CITY OF DELAND
REGULAR MEETING OF THE PLANNING BOARD
MAY 8, 2024 AT 5:00 PM
CITY HALL, COMMISSION CHAMBERS
120 SOUTH FLORIDA AVENUE

**PLANNING STAFF
REPORT TO
CITY OF DELAND PLANNING
BOARD**

**PLANNING STAFF REPORT
TO
CITY OF DELAND PLANNING BOARD**

Issues for record SP24-037

Exhibit 3 – Current Allowance of a 6' Fence

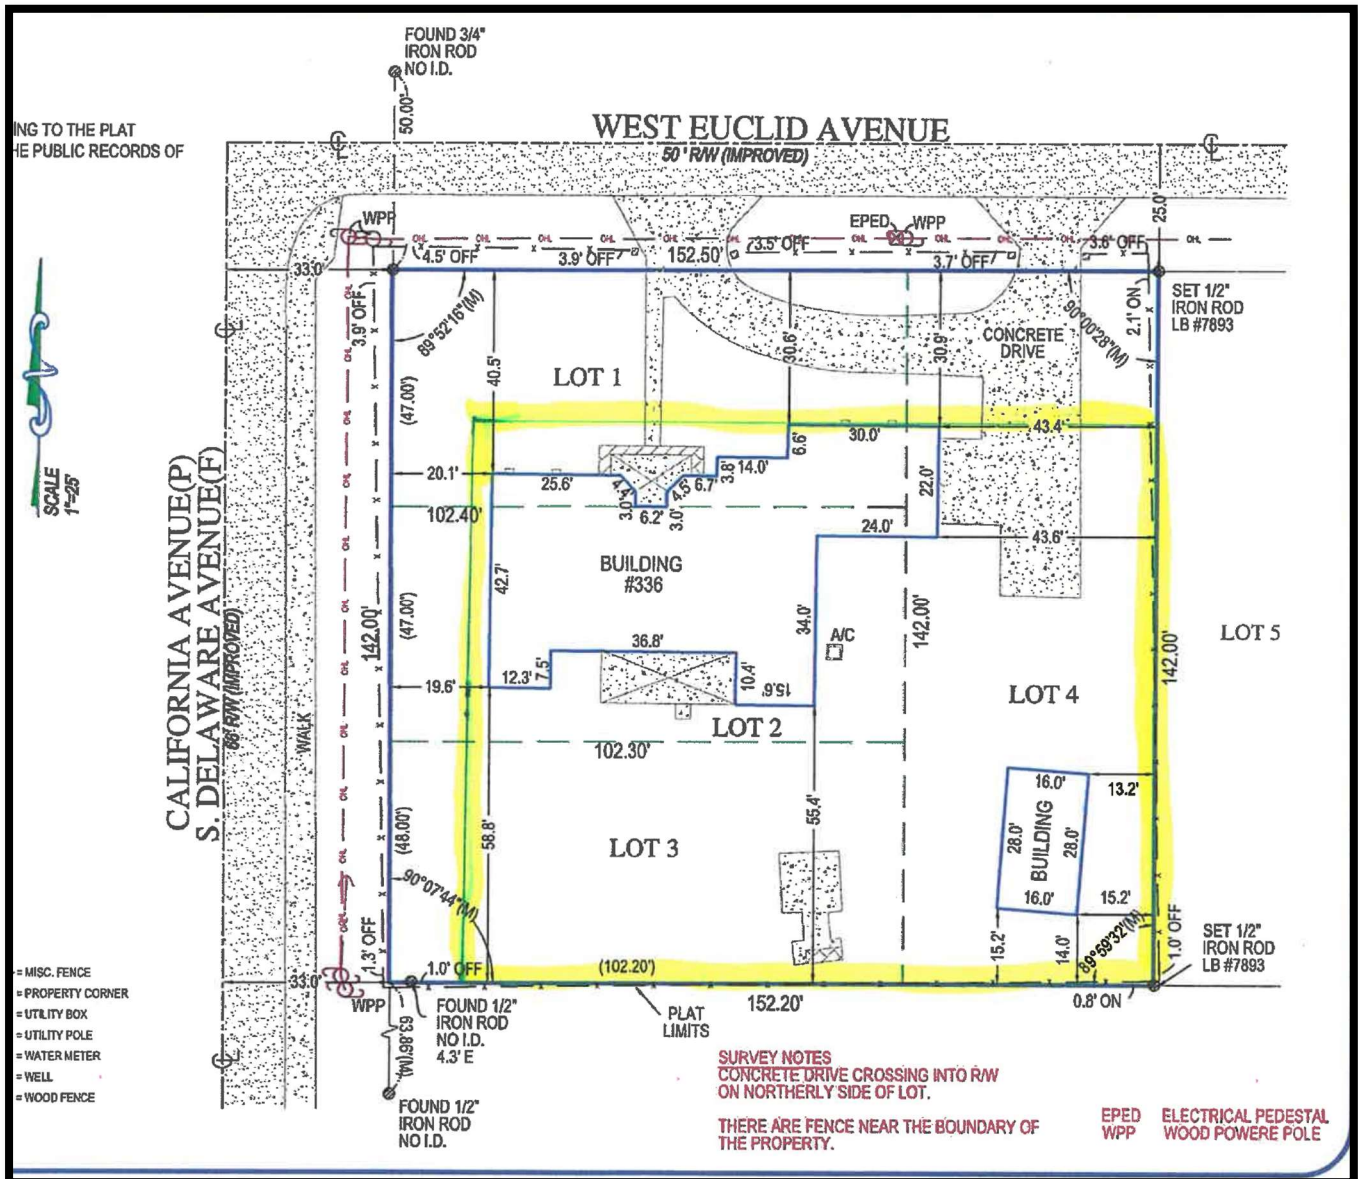
inadequate privacy screening if a six-foot tall fence were to be used. (Exhibit 6) Landscaping could be used by the applicant to achieve increased privacy if a six-foot fence were to be used as there is no height limitation for landscaping.

The applicant could construct a six-foot tall fence at the rear and sides of the property as is allowed by the Land Development Regulations and still maintain privacy. The applicant could also pursue other options to provide a visual screen such as hedges, bamboo, or some other plant material.

STETSON UNIVERSITY
RESIDENTIAL HALL
FINAL ENGINEERING PLANS
GEOMETRY, SIGNAGE &
STRIPING PLAN

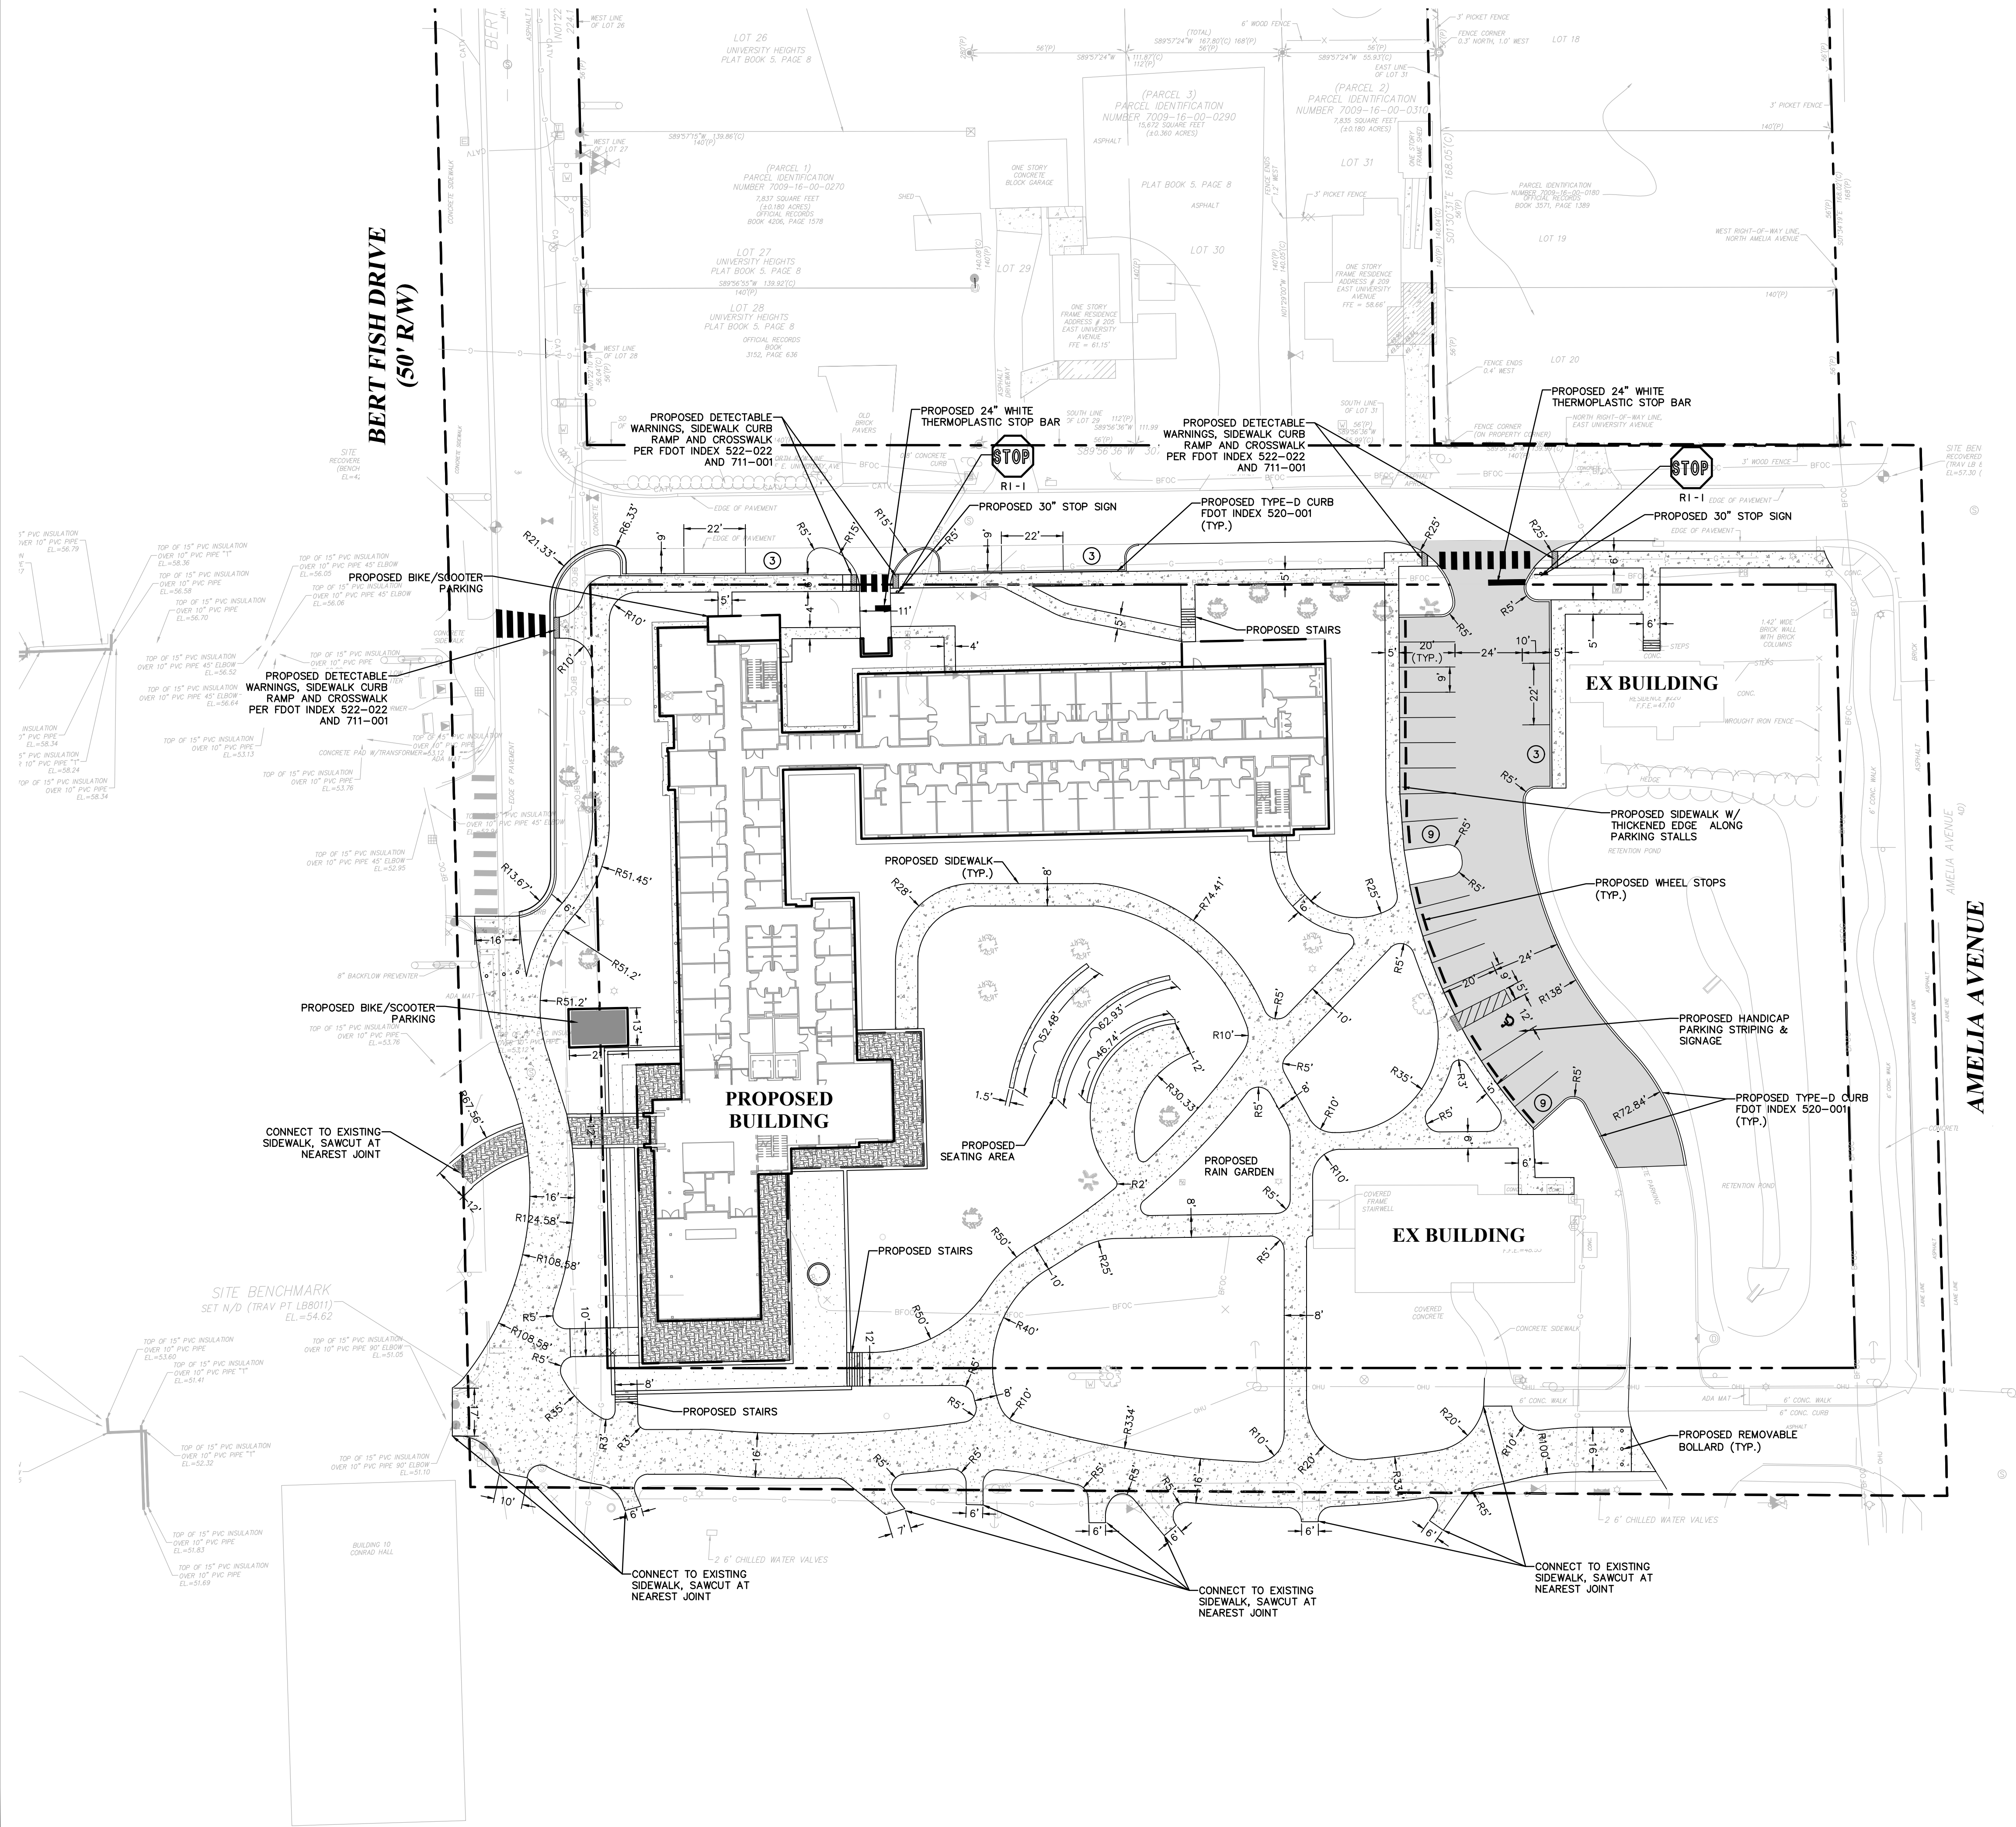
Planning	Draft	Dumpster Enclosure Will there be a new dumpster enclosure built at the site? If so, please show the location on the site plan. Any newly proposed enclosures must be constructed with similar materials to the primary structure.	C6	Samuel Nelson	Samuel Nelson	Yes
Planning	Draft	Community Design Review *Request sent to the City Architect 2/28/2024*		Samuel Nelson	Samuel Nelson	Yes
Planning	Draft	Building Dimensions Please show the dimensions of the proposed building on the plan.	C7	Samuel Nelson	Samuel Nelson	Yes
Planning	Draft	Setbacks Please provide the setbacks of the proposed building from adjacent property lines.	C7	Samuel Nelson	Samuel Nelson	Yes
Planning	Draft	ADA Parking Spaces The cover page shows that two ADA parking spaces will be provided. Only one is visible on the plan. Is the other proposed ADA space able to be placed nearer to the entrance of the newly proposed building?	C7	Samuel Nelson	Samuel Nelson	Yes

**STETSON UNIVERSITY
RESIDENTIAL HALL
FINAL ENGINEERING PLANS
OVERALL DEVELOPMENT PLAN**

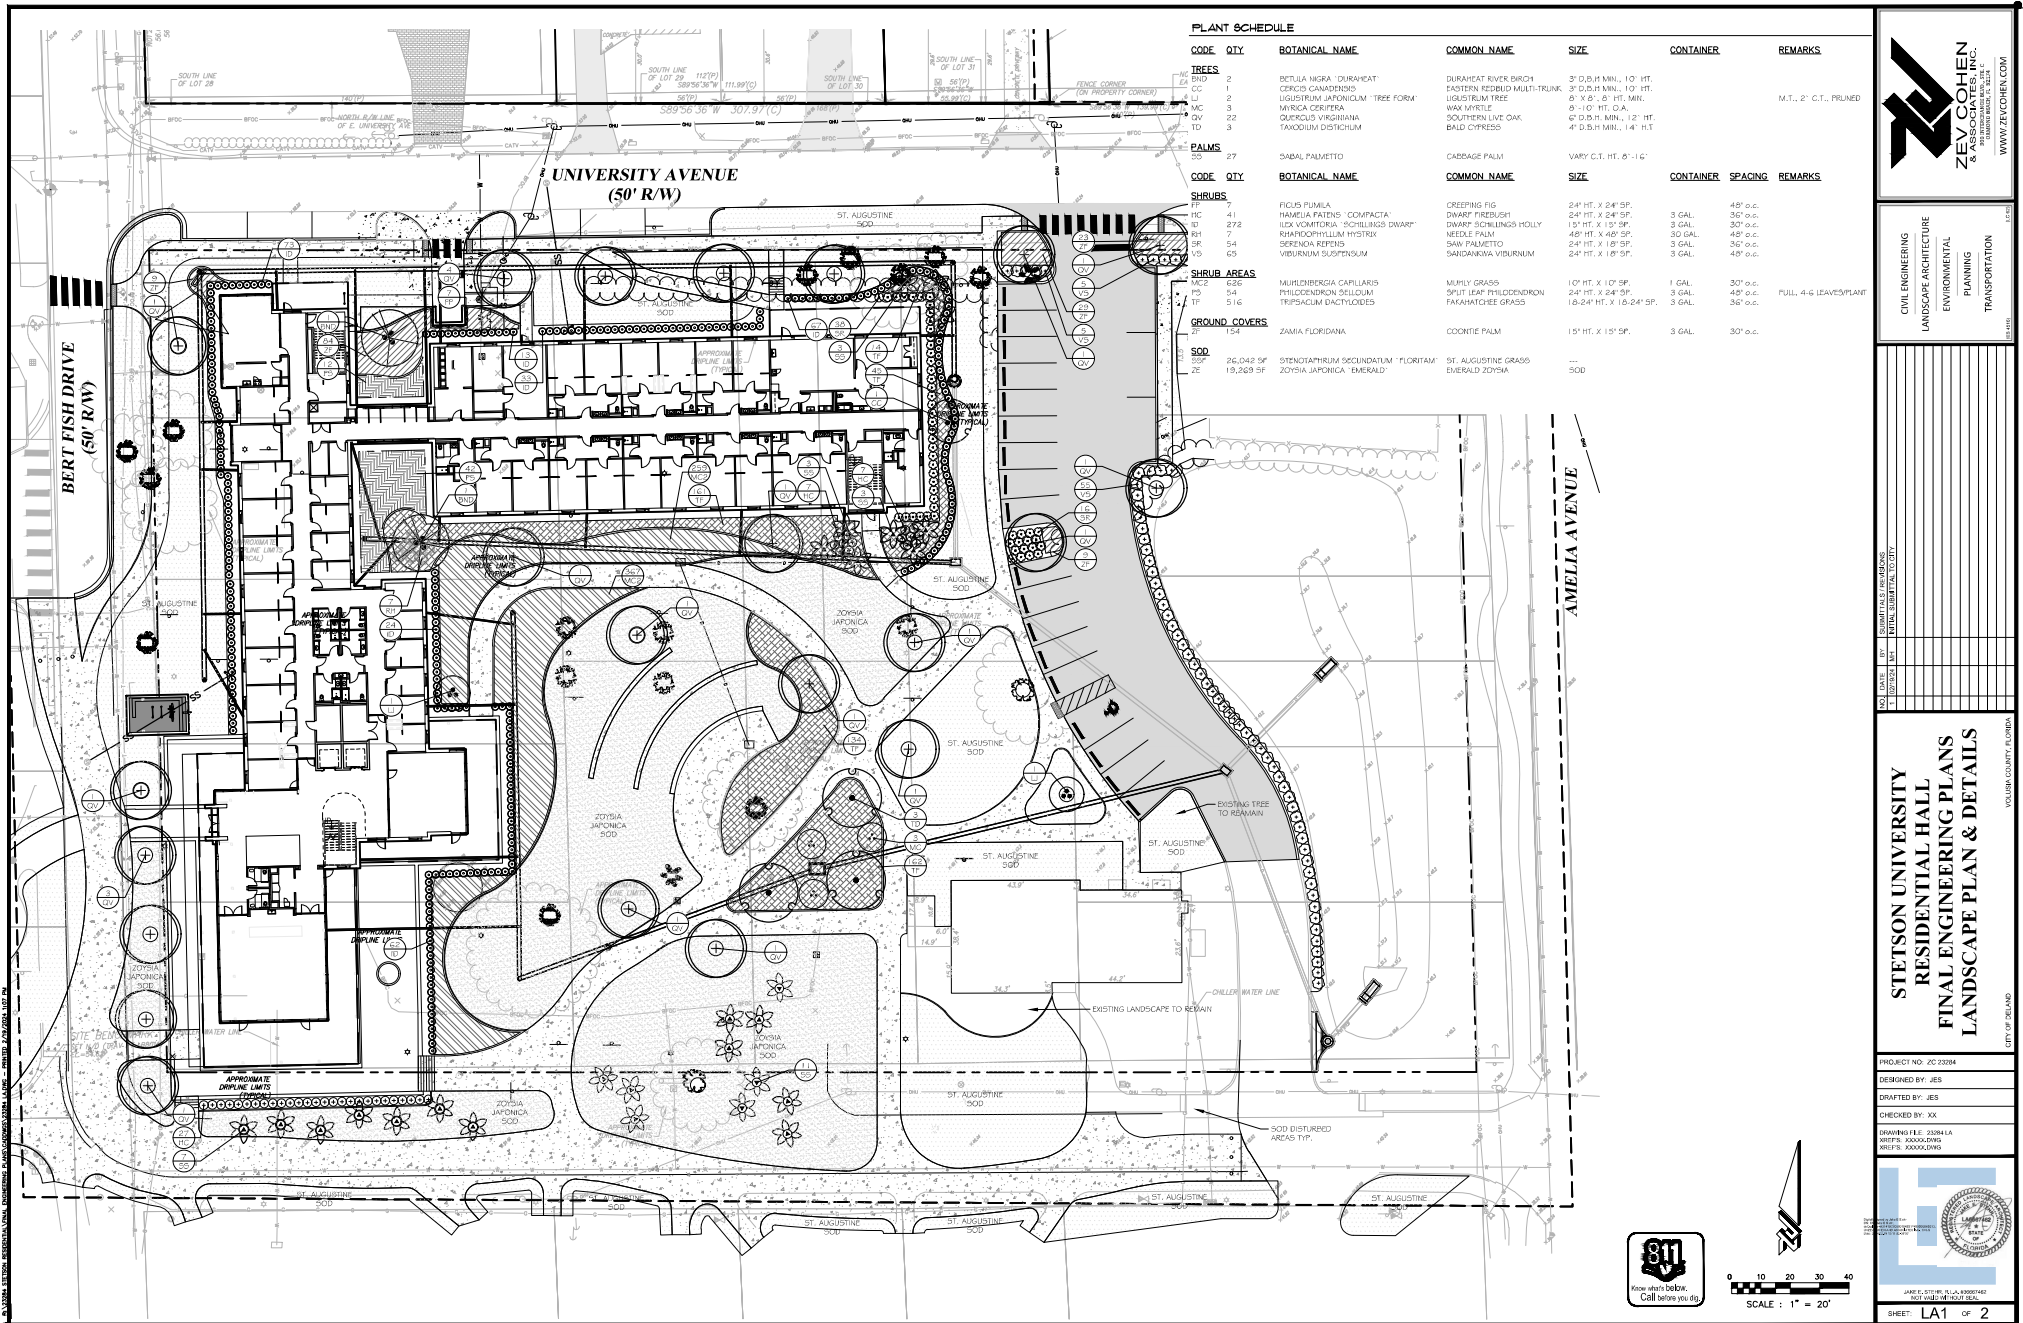
Discipline	Status	Details	Attached To	Created By	Last Updated By	Modifications Required
Planning	Draft	Lot Combination A lot combination will be required for this project prior to approval of the site plan.	C6	Samuel Nelson	Samuel Nelson	Yes
Planning	Draft	Parking Lot Lighting Will there be lighting provided for the proposed parking lot? If so, please show this in a photometric plan.	C6	Samuel Nelson	Samuel Nelson	Yes
Planning	Draft	Mechanical Equipment Please show and proposed exterior mechanical equipment. Note: 33-94.03 (4) 4. Building mechanical equipment, service, delivery, and work areas, shall be visually screened from pedestrian areas and from public view. These areas shall be located as far as reasonably possible from adjoining residential uses. Vertical lift and overhead garage type doors should not be located on principal facades abutting public rights-of-way.	C6	Samuel Nelson	Samuel Nelson	Yes
